22 SUB2008-00009

TAYLOR POINTE SUBDIVISION, UNIT TWO

DETAIL SITE PLAN

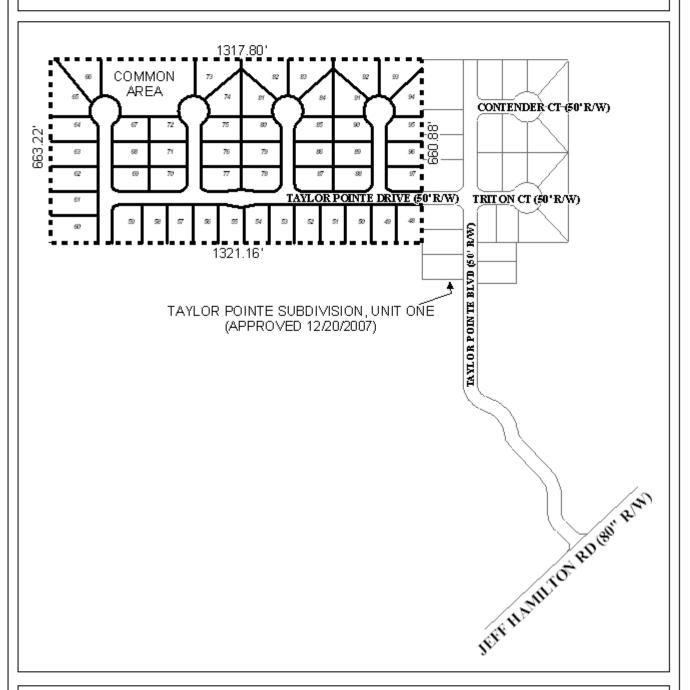
The site involves the creation of new streets which must be constructed and dedicated to County Engineering standards, including a street stub to the South. Most of these streets are short culde-sacs. The one main road is approximately 1200 feet long and straight, and would therefore require calming devices; the only kind of calming device that the County will accept is a traffic circle. Based on the length of the street, it is recommended that the main street feature one traffic circle as proposed; however, as proposed the street is illustrated as having bump outs, the developer should create an island illustrated as common area. The suitable location for this circle; however, size, location, and design will ultimately be subject to County Engineering approval.

In addition, as a means of access management, a note should be placed on the final plat stating that lots 69, 70, 77, 78, 87, 88, and 97 are corner lots therefore, a note should be placed on the Final Plat limiting each lot to one curb cut each, with the size, design and location to be approved by County Engineering and conform to AASHTO standards.

The plat illustrates a large common area, therefore, all common areas should be labeled and a note should be placed on the Final Plat stating that maintenance of common areas will be property owners' responsibility.

- 1) the provision of one traffic circle on Taylor Pointe Drive between lots 54 and 55, size, location, and design be approved by County Engineering and conform to AASHTO standards;

- 2) the placement of a note on the Final Plat stating that lots 69, 70, 77, 78, 87, 88, and 97 are corner lots and are limited to one curb cut each, with the size, design and location to be approved by County Engineering and conform to AASHTO standards;

- 3) the labeling of all common areas and the placement of a note on the final plat stating that maintenance of common areas will be property owners' responsibility;
